EDWIN I. HATCH NUCLEAR PLANT
UNIT 1

CONTAINMENT LEAK RATE TEST PROGRAM

II. PROPOSED PLANT MODIFICATIONS

Penetrations Requiring Modification
To Conform to 10CFR50, Appendix J

PENETRATION X25: ADD A BLOCKING VALVE AND TEST CONNECTION BETWEEN VALVE T48-F118A AND THE PENETRATION
Figure 1 (Reference H-16000)

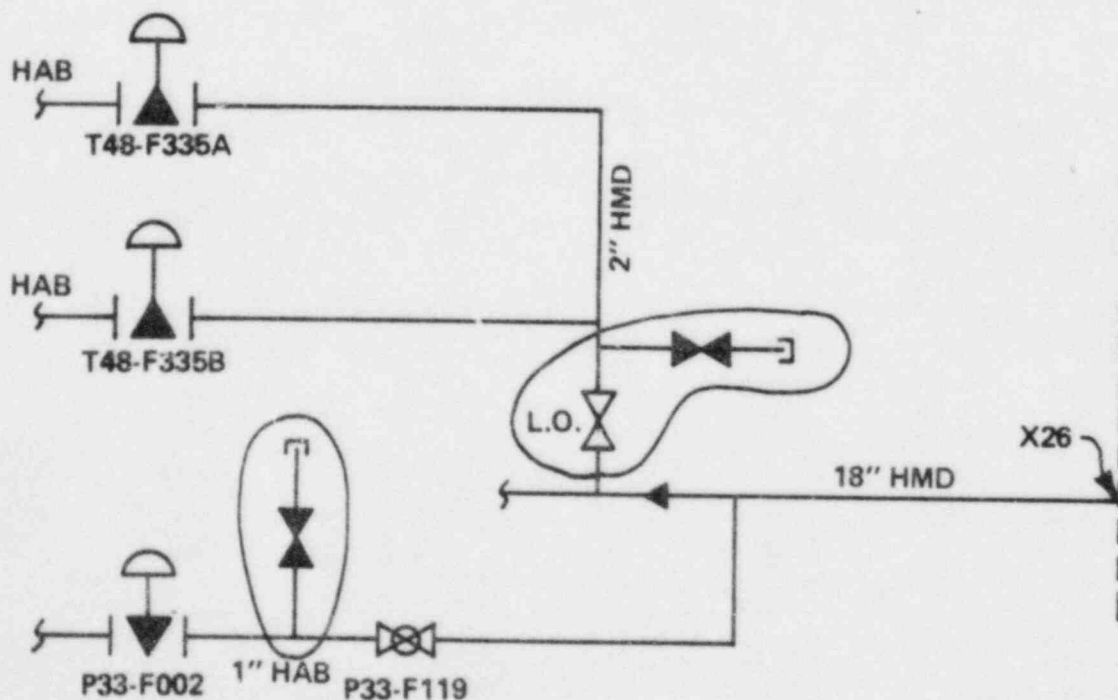
Penetration X25 - Vent Purge Supply:

Valve T48-F118A is a globe valve pressurized in the reverse direction during leakage testing. The valve cannot be conservatively tested in the reverse direction. A blocking valve and test connection installed as shown on Figure 1 will allow testing of valve T48-F118A in the proper direction. The modification shown in Figure 1 will also allow pressurizing of valves T48-F114 and T48-F322 in the correct direction. This arrangement is beneficial, although the two control valves may be conservatively tested as installed. This modification requires one 2" and one 3/4" ASME Section III Class 2 valves.

PENETRATION X26: ADD TEST CONNECTIONS AND A BLOCKING VALVE
Figure 2 (Reference H-16024 and H-16276)

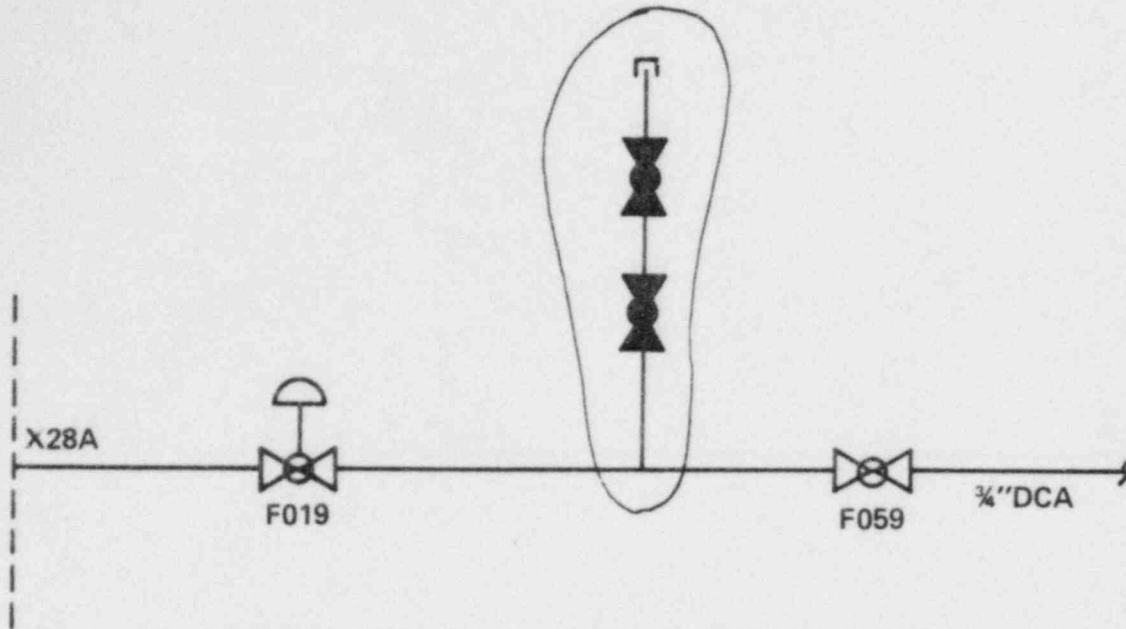
Penetration X26 - Vent Purge Return/H₂ & O₂ Analyzer:

This penetration has three control valves not conservatively tested in the reverse direction: T48-F335A and B, and P33-F002. As shown on Figure 2, T48-F335A and B can be tested in the correct direction by installing one blocking valve and a single valve test connection in the common line. P33-F002 has a blocking valve upstream and needs only the addition of a single valve test connection. Two 3/4" and one 2" ASME Section III Class 2 valves are required for these modifications.

Figure 3 (Reference H-16066)

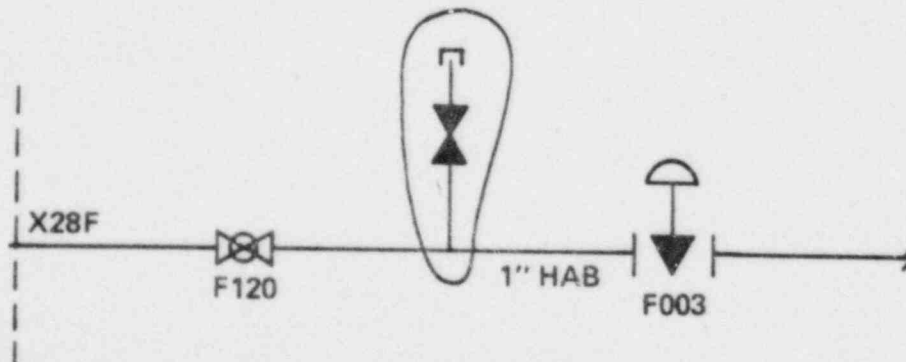
Penetration X28A - Recirculation Sample

Valve B31-F019 is a globe valve that cannot be conservatively tested in the reverse direction. As shown on Figure 3, a blocking valve is presently installed but a test connection is required between B31-F019 and the blocking valve. Two 3/4" ASME Section III Class 1 valves are required for this modification.

PENETRATION X28A: ADD A TEST CONNECTION

Figure 4 (Reference H-16276)

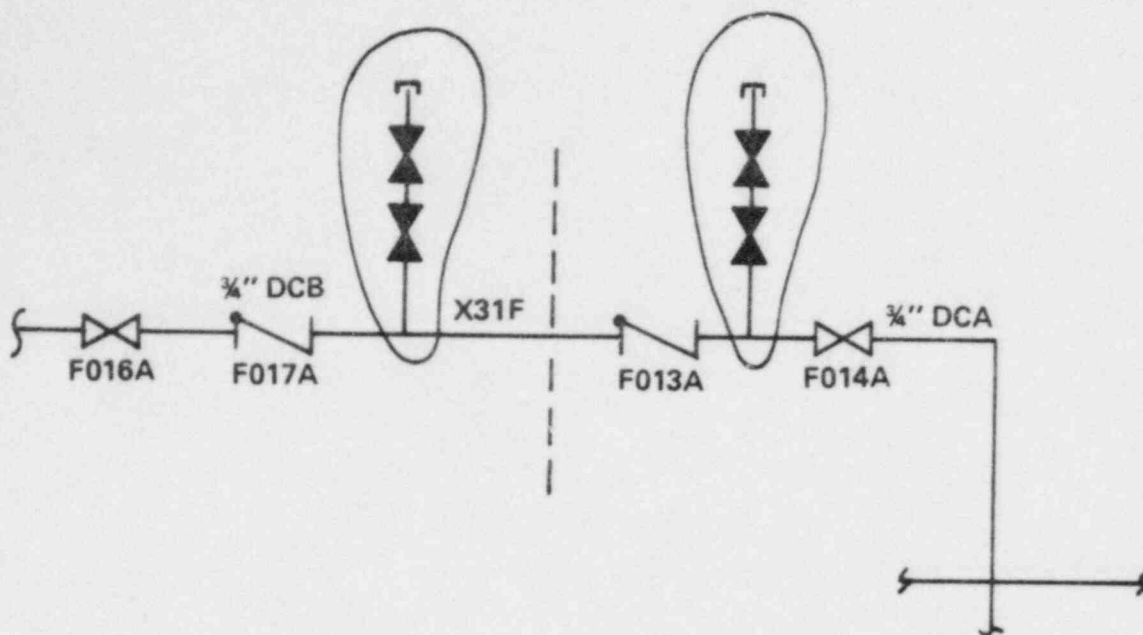
Penetration X28F - H₂ & O₂ Analyzer:

P33-F003 is a control valve non-conservatively pressurized in the reverse direction. As shown on Figure 4, a blocking valve is presently installed, but a test connection is required between P33-F003 and the blocking valve. One 3/4" ASME Section III Class 2 valve is required for this modification.

PENETRATION X28F: ADD A TEST CONNECTION

Figure 5 (Reference H-16066)

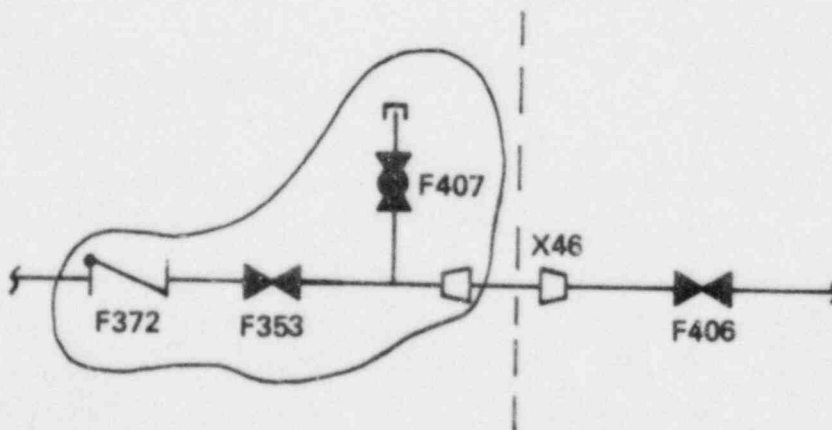
Penetration X31F - Recirculation Pump Seal Water:

The present system design does not provide testing capabilities for check valves B31-F013A or B31-F017A. Test connections are required as shown in Figure 5. This modification requires four 3/4" ASME Section III Class 2 valves.

Penetration X59A - Recirculation Pump Seal Water:

This penetration design is identical to X31F (see Figure 5). Testing capabilities are not provided for check valves B31-F013B or B31-F017A. Test connections are required as shown in Figure 5. This modification requires four 3/4" ASME Section III Class 2 valves.

**PENETRATION X31F: ADD TEST CONNECTIONS BETWEEN VALVES
B31-F017A, B31-F013A, AND B31-F014A.
PENETRATION X59A IS IDENTICAL.**

Figure 7 (Reference H-16000)

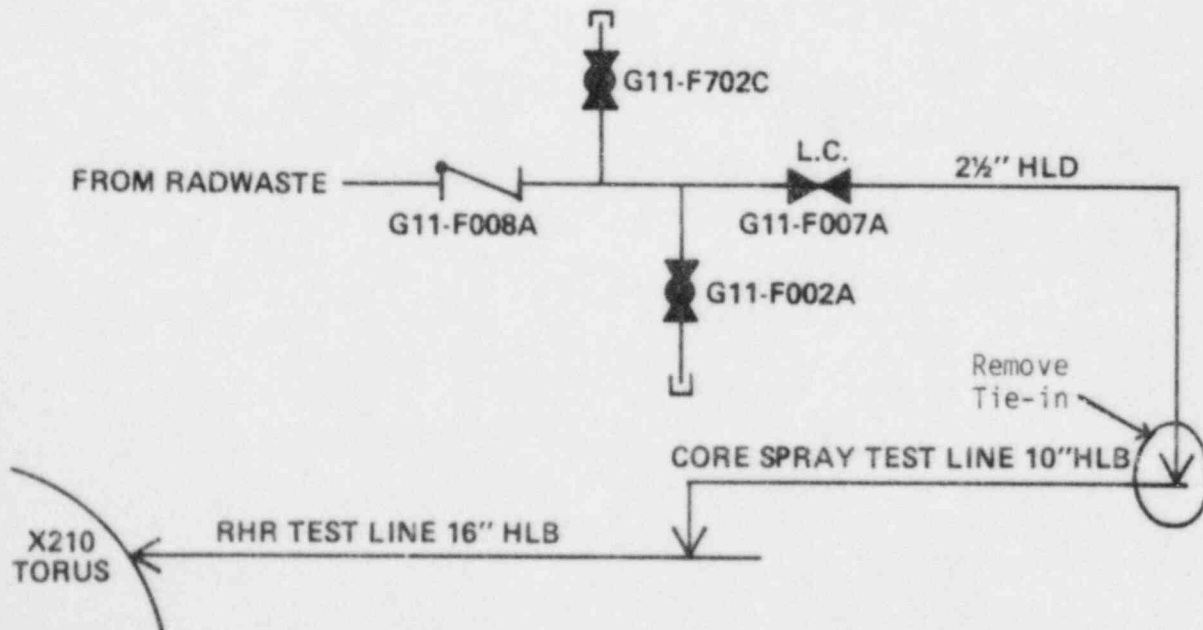
Penetration X205 - Containment Purge and Inerting:

Globe isolation valve T48-F118B cannot be tested conservatively in the reverse direction. The modification shown in Figure 7 is similar to the one discussed for penetration X25.

PENETRATION X205: INSTALL A BLOCKING VALVE AND TEST CONNECTION BETWEEN T48-118B AND THE PENETRATION

Figure 9 (Reference H-16276)

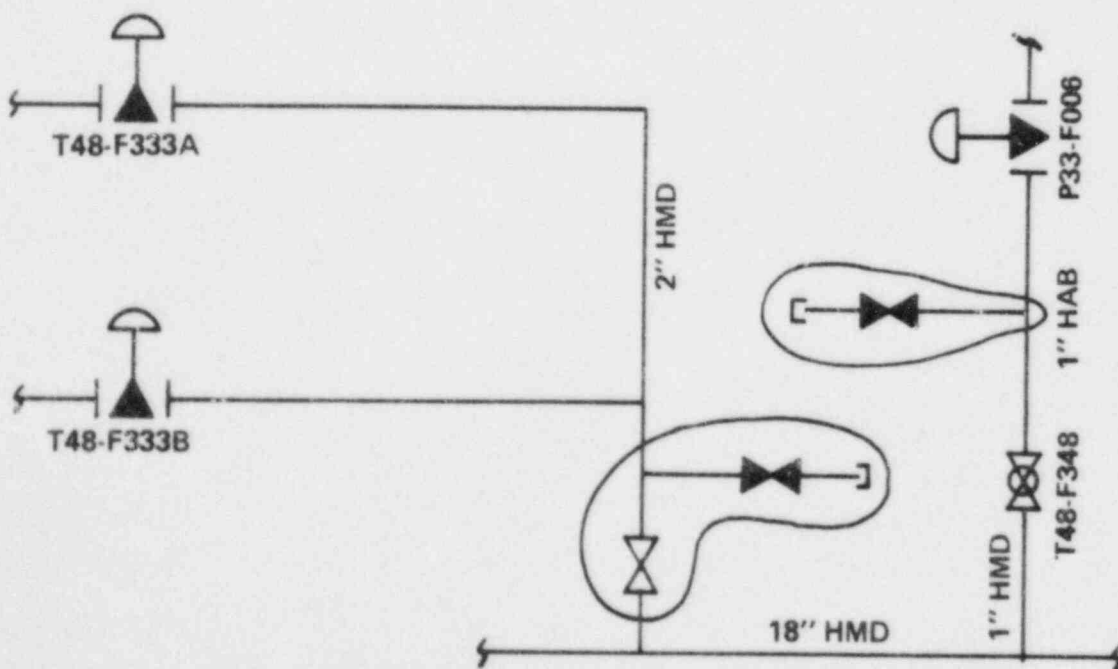
Penetration X217 - H₂ & O₂ Analyzer:

P33-F007 cannot be leakage tested in the correct direction and a reverse pressure test is not conservative. A blocking valve is part of the present system design. Therefore, an installed test connection will provide the required leakage testing capability for this valve (see Figure 9). This modification requires one 3/4" ASME Section III Class 2 valve.

PENETRATION X217: ADD A TEST CONNECTION BETWEEN P33-F007 AND P33-F126

Figure 10 (Reference H-16024 and H-16276)

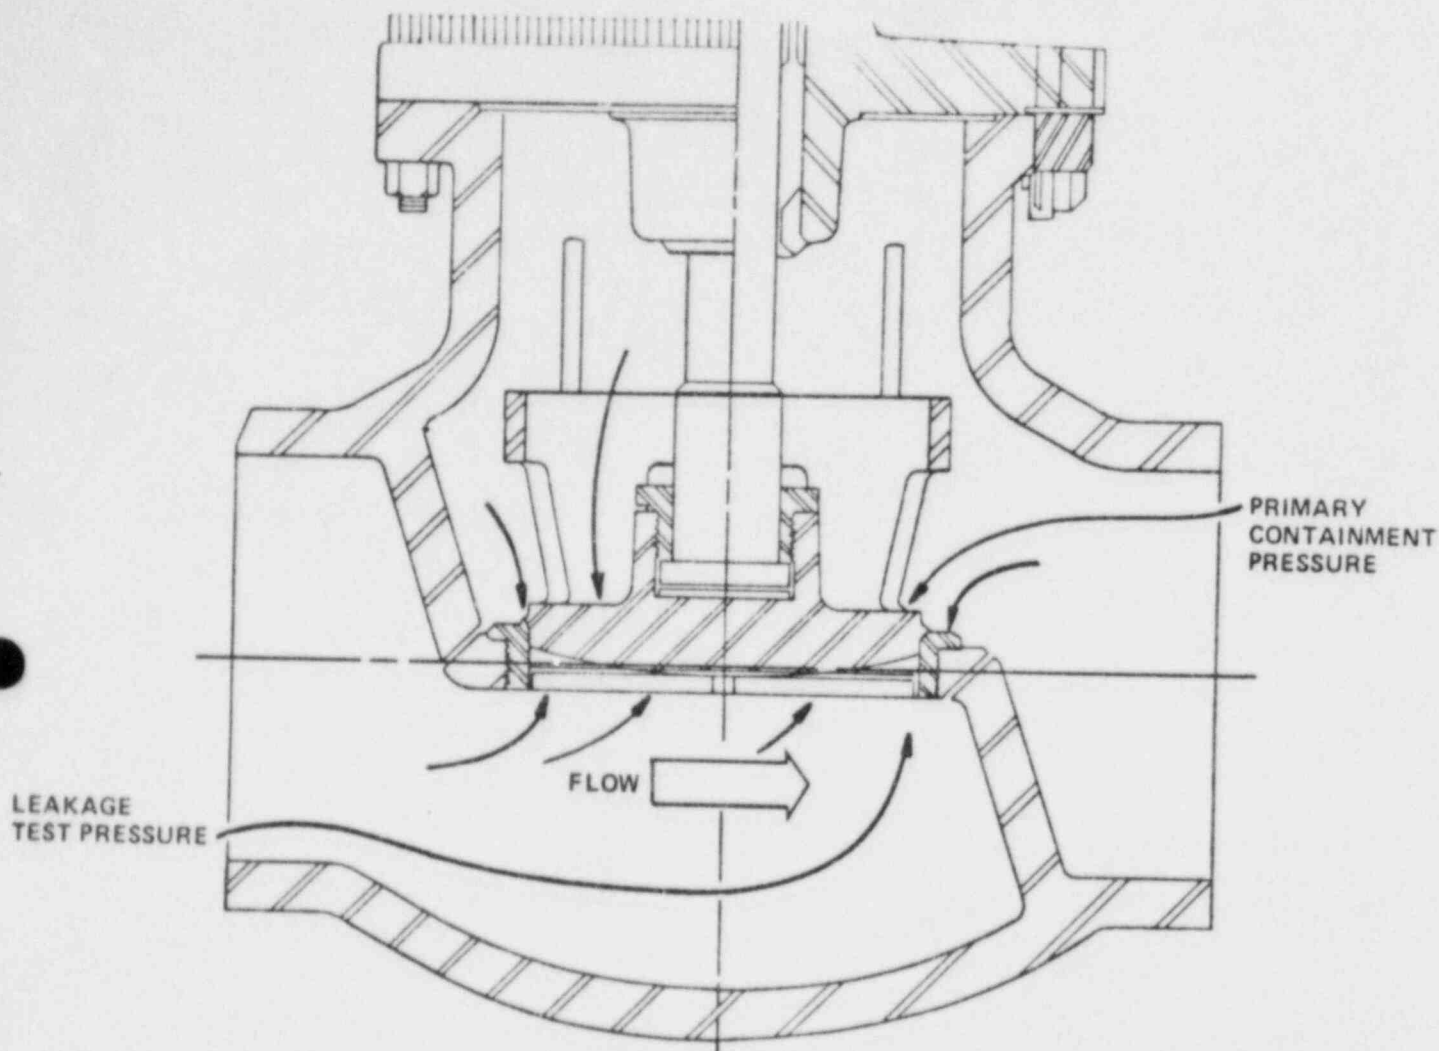
Penetration X220 - Vent Purge Outlet/H₂ & O₂ Analyzer:

Valves T48-F333A/B are control valves that are utilized as primary containment isolation valves. The valves cannot be conservatively tested in the reverse direction and are not presently capable of being tested from the containment direction. The addition of a blocking valve and a test connection as shown in Figure 10 will enable acceptable leakage rate testing of these valves. Isolation valve P33-F006 has a blocking valve installed, but requires the installation of a test connection for leakage rate testing. This modification requires one 2" and two 3/4" ASME Section III, Class 2 valves.

PENETRATION X220: ADD A BLOCKING VALVE AND TEST CONNECTION BETWEEN T48-F333A/B AND THE PENETRATION, ADD A TEST CONNECTION BETWEEN T48-F348 AND P33-F006.
